GE Nuclear Energy

April 16, 1996

MFN 050-96
Docket No. 52-001

ABWR Design Change Assessment Review of FOAKE Design Changes

Figure 2.15.5a Control Room Habitability Area HVAC System

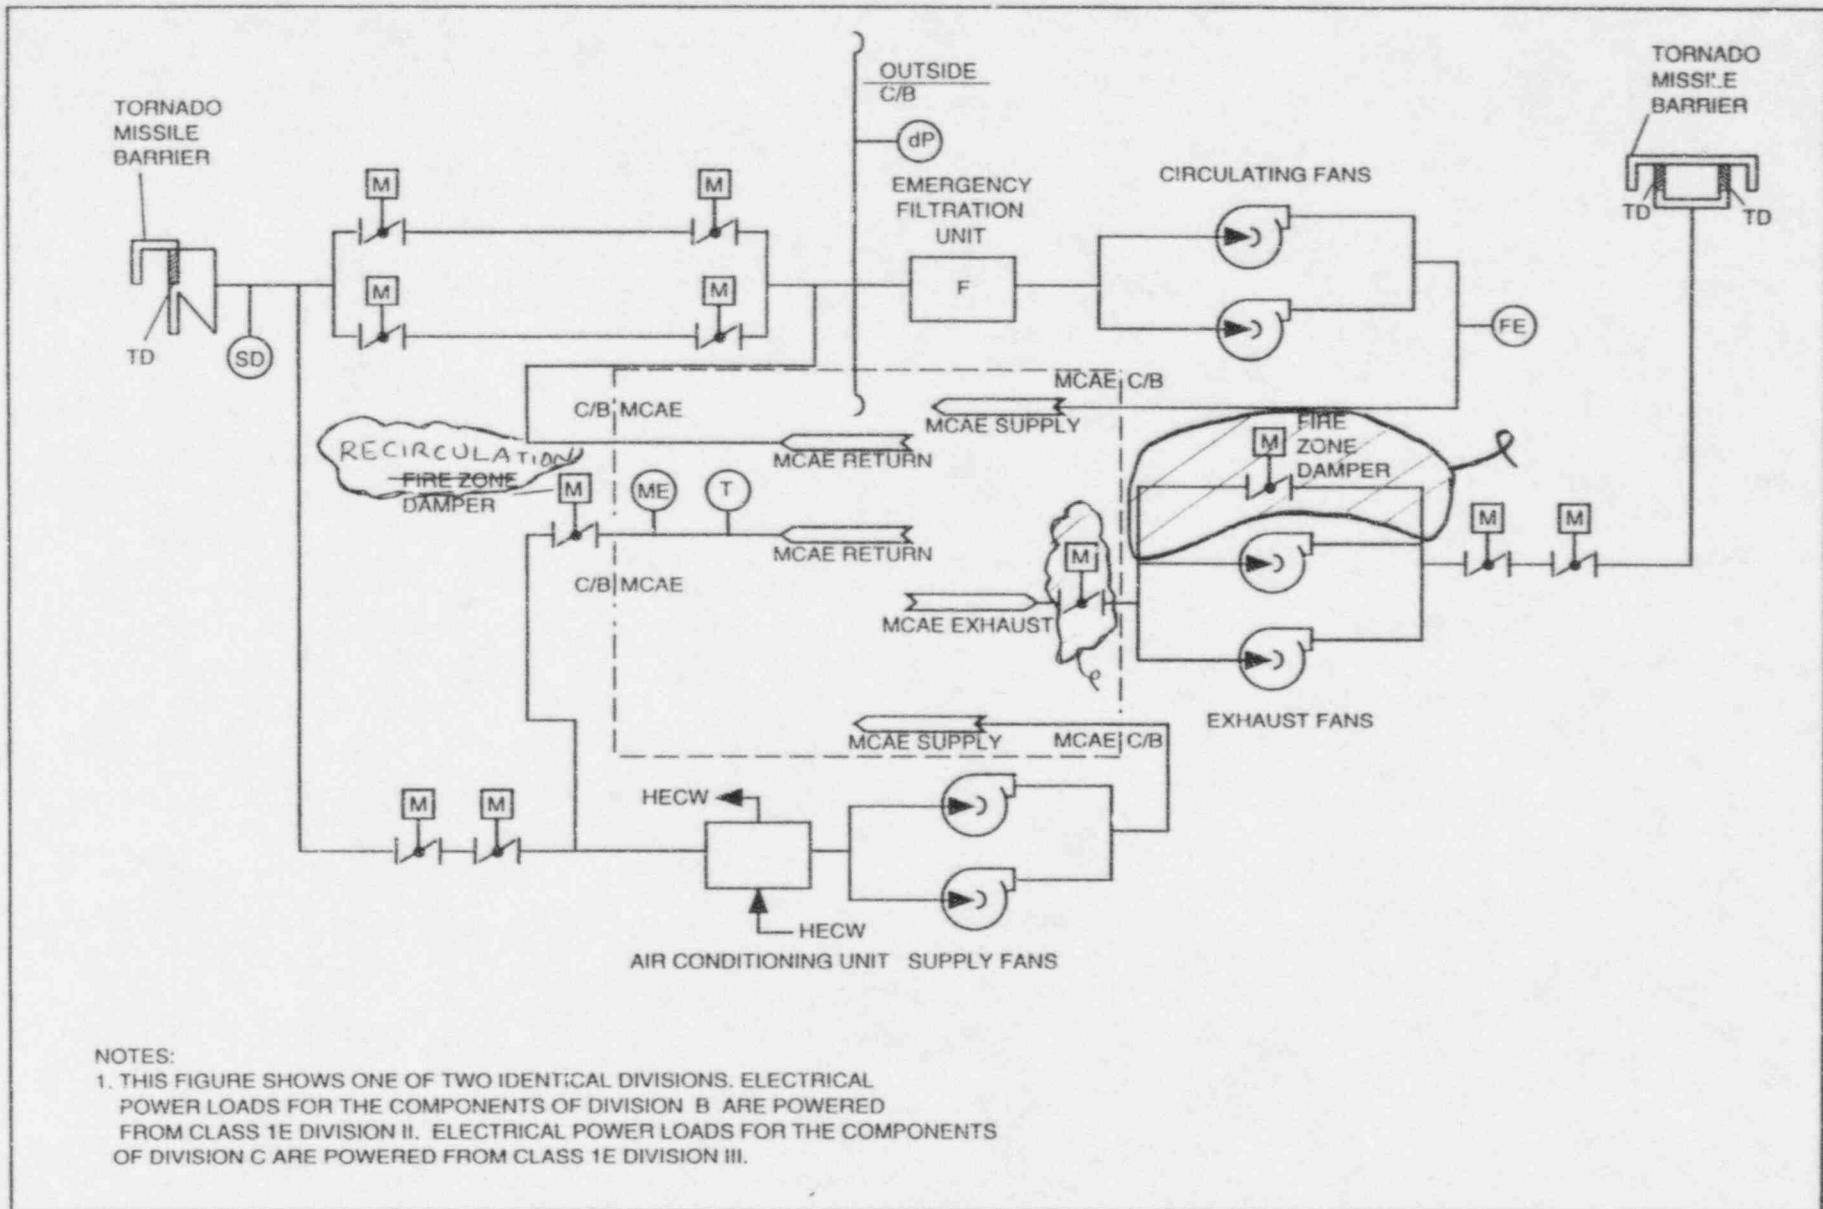
**Change of Smoke Removal Method and
Duct Connections**

The smoke removal mode is manually initiated by closing the recirculation damper, ~~stopping the exhaust fan, and opening the exhaust fan bypass damper~~ to allow outside air purging of the affected Control Building area. The normal operating mode is used to remove smoke from the battery rooms.

FIGURE 9.4-1 CONTROL BUILDING HVAC FLOW DIAGRAM (Sheet 1 of 5)
 ABWR E-CD/Tier 2
 Rev. 0
 21-535

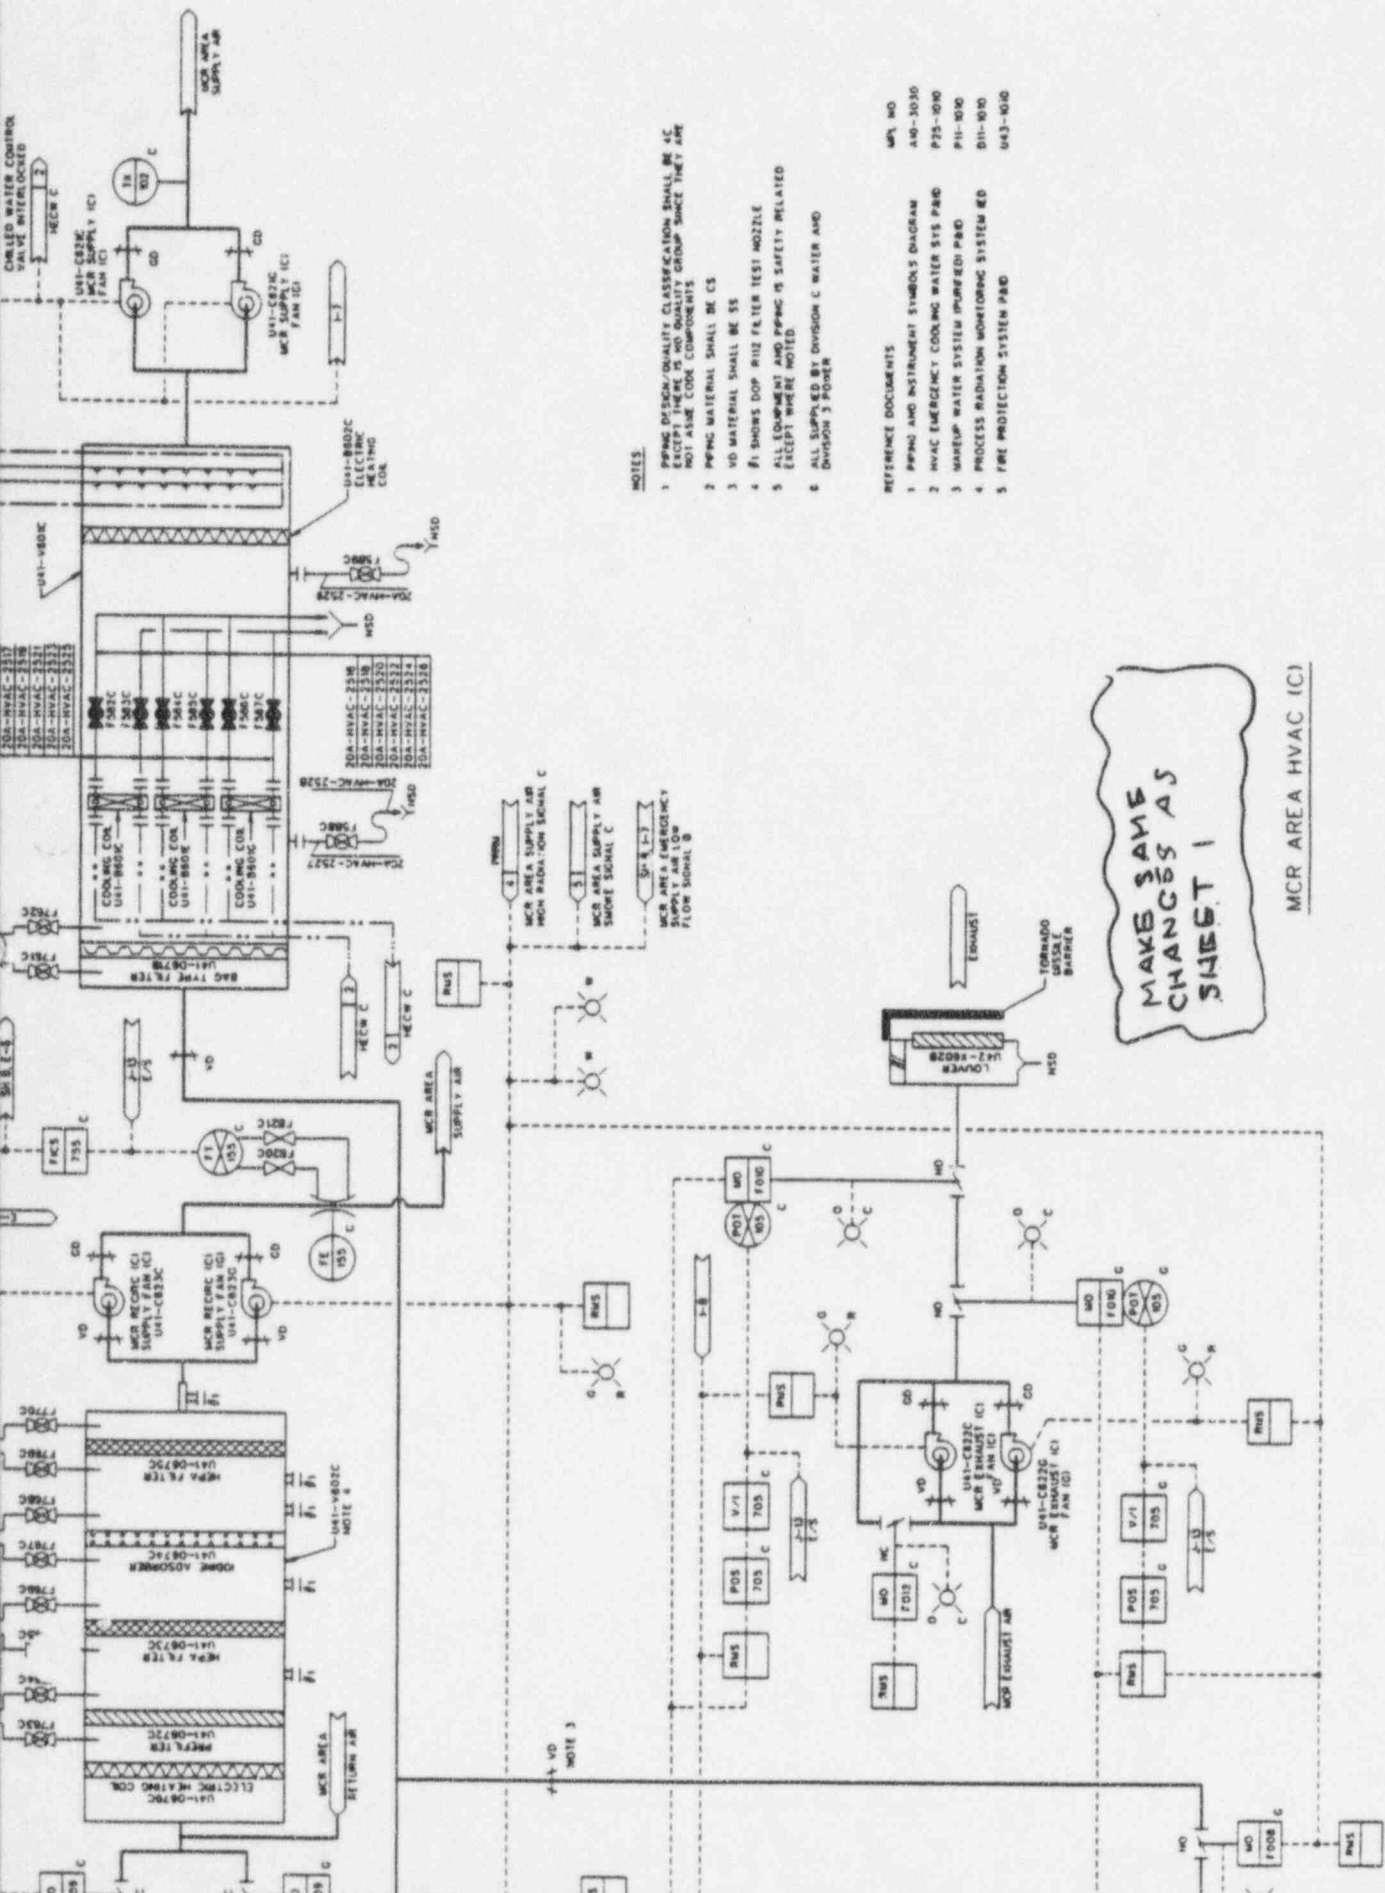
starting both exhaust fans at high speed in conjunction with a supply fan,
 The main control area envelope is normally exhausted from the recirculation plenum by one of the exhaust fans. Smoke removal is accomplished by ~~stopping the exhaust fans~~ and realigning the dampers for exhausting directly to the exhaust vent. ~~Thus, 100% fresh air is circulated and exhausted by pressurization to clear the smoke.~~ The above changeover is under manual control from the main control room. Operating personnel in the control room exercise this option in response to signals from the smoke detection sensors located in the subject spaces and in the associated ductwork.

FIGURE 9.4-4 R/B SAFETY-RELATED ELECTRICAL EQUIPMENT HVAC SYSTEM (Sheet 1 of 3)
ABWR DCD/Tier 2 Rev. 0 21-543

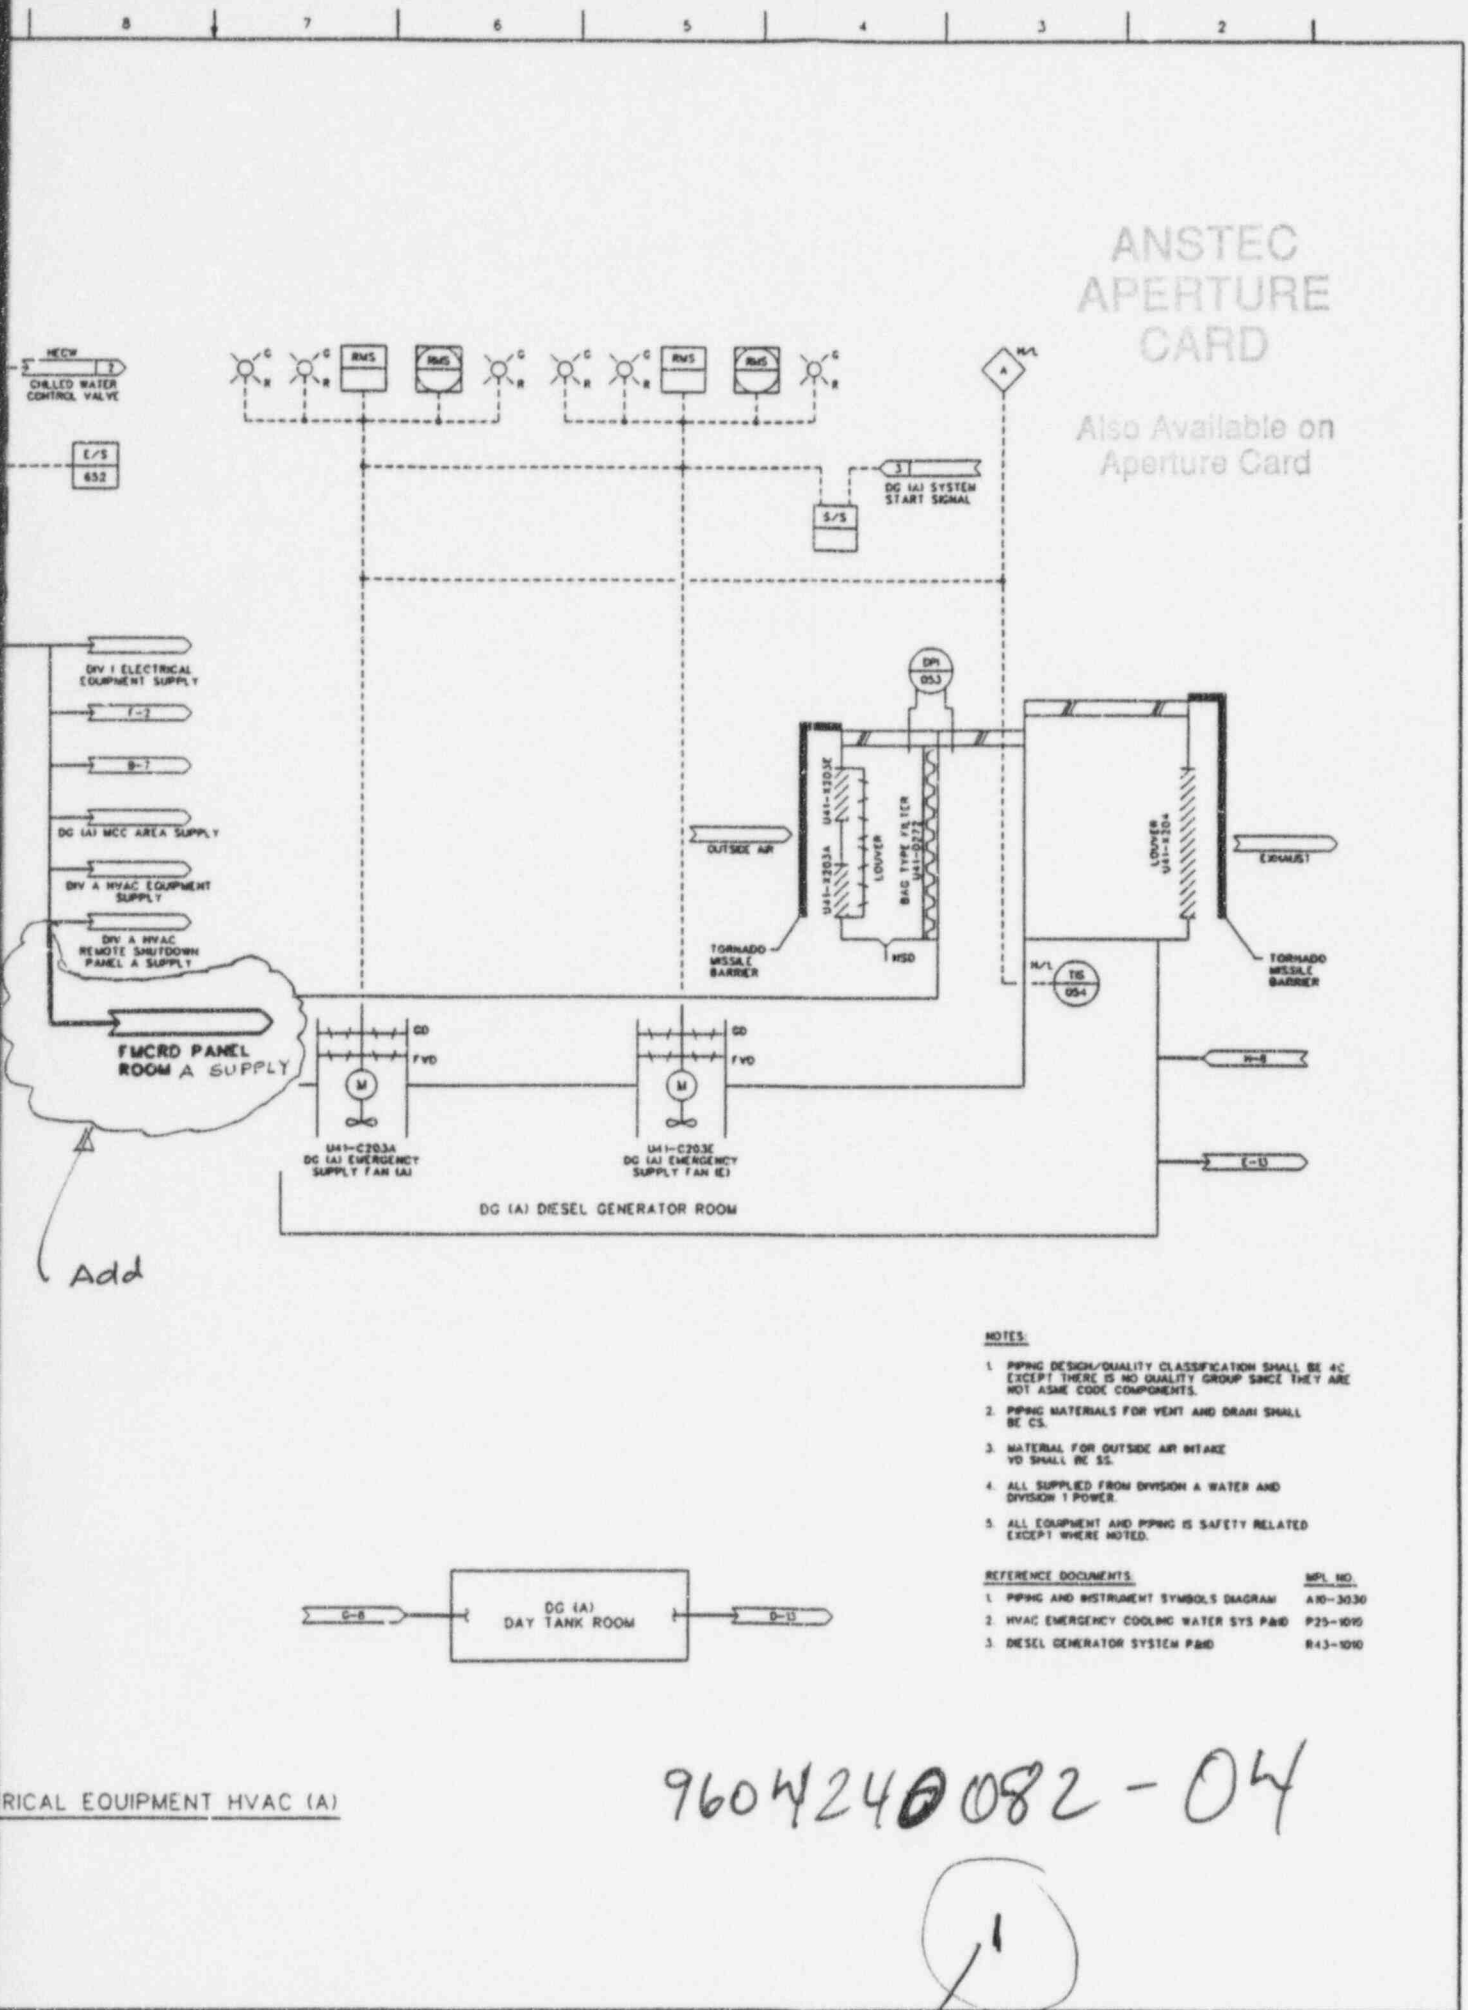
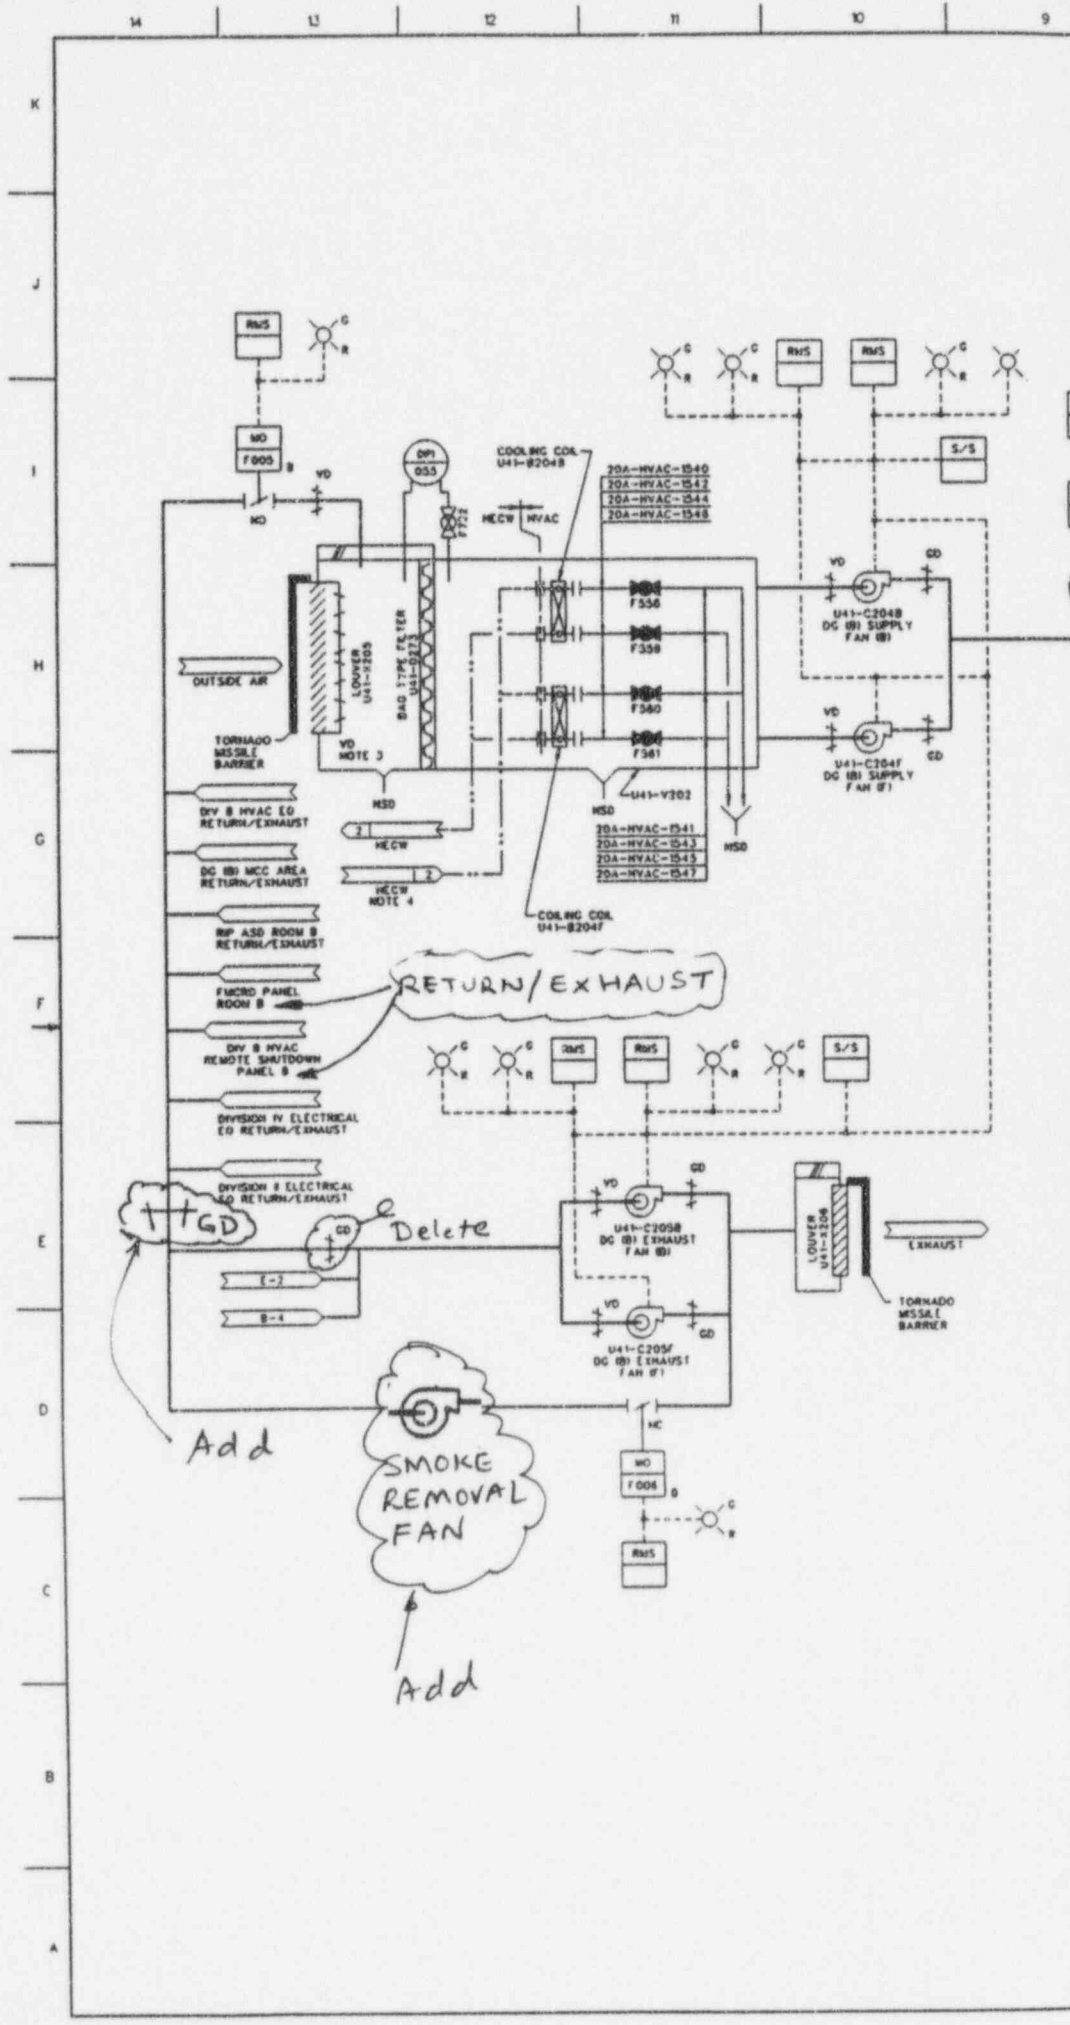
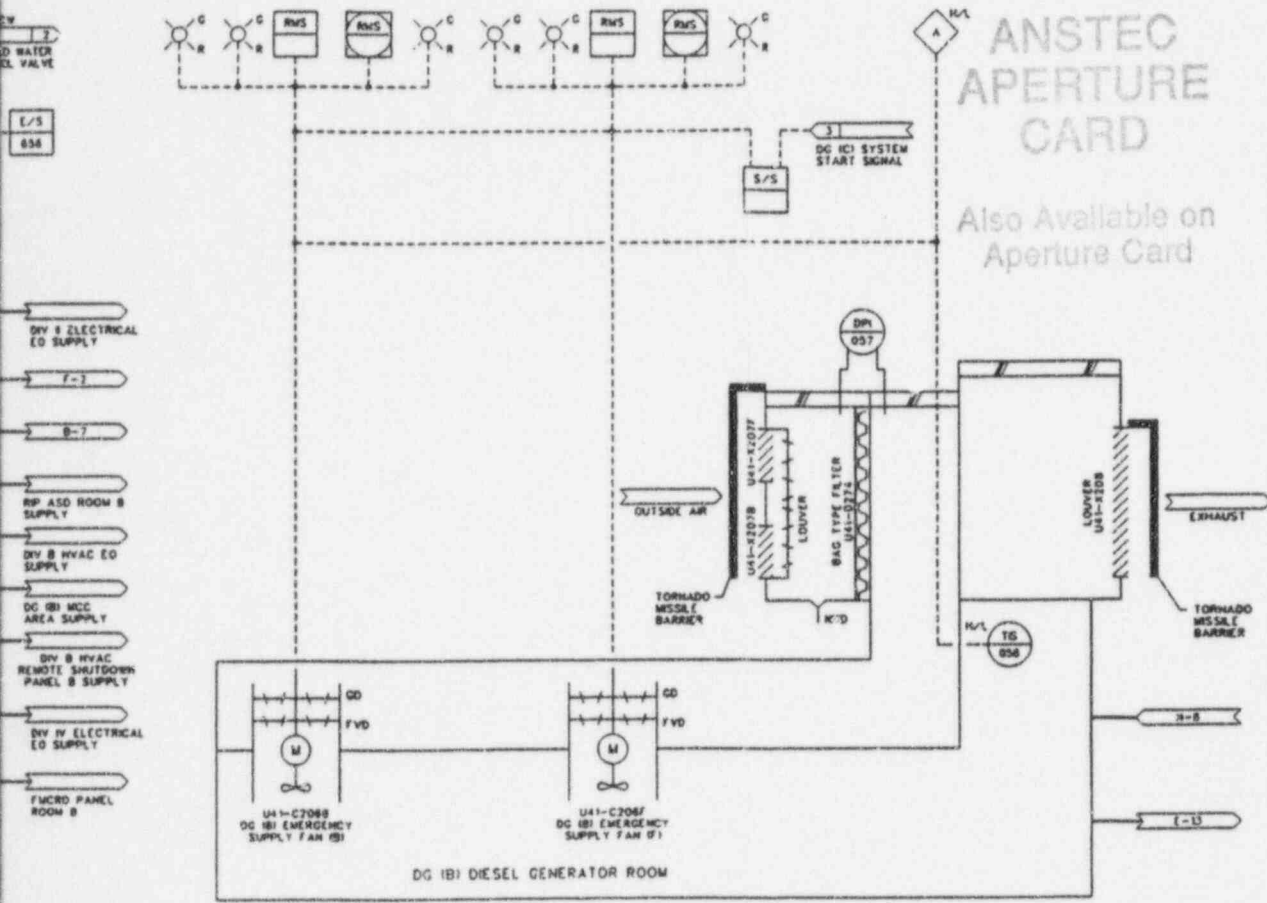
Add
